Technical Bulletin TB110901 issue 2

M0910 power supply, internal component issue.
27/02/2012

PRODUCT: SLE 4000/5000 410 PSU PROBLEM

Picture 3

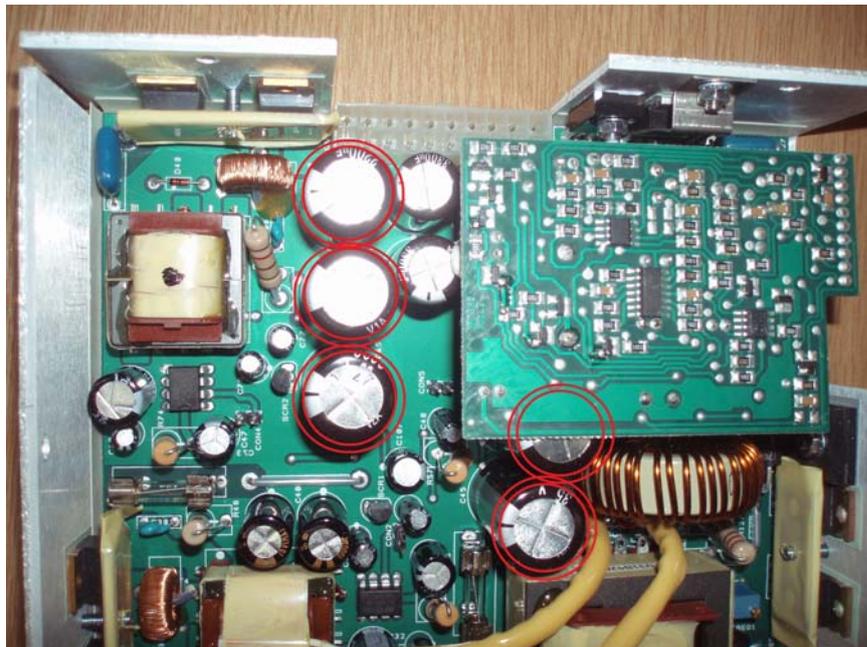
- If the PSU model number is FP110-410 and the serial number is outside of the specified range please inspect capacitors (C45-C49-C65-C78-C88) as shown in the picture 3 below.

Picture 3 shows the locations of the capacitors that require inspection. The suspect capacitors are circled red.

- If any of the capacitors are tall capacitors as shown in picture 4 please contact service@sle.co.uk to obtain a replacement unit.
- If the capacitors are not the same size as the PCB board as shown in picture 5 then the PSU does not contain any of the affected batch and the PSU can be reinstalled and returned to use.
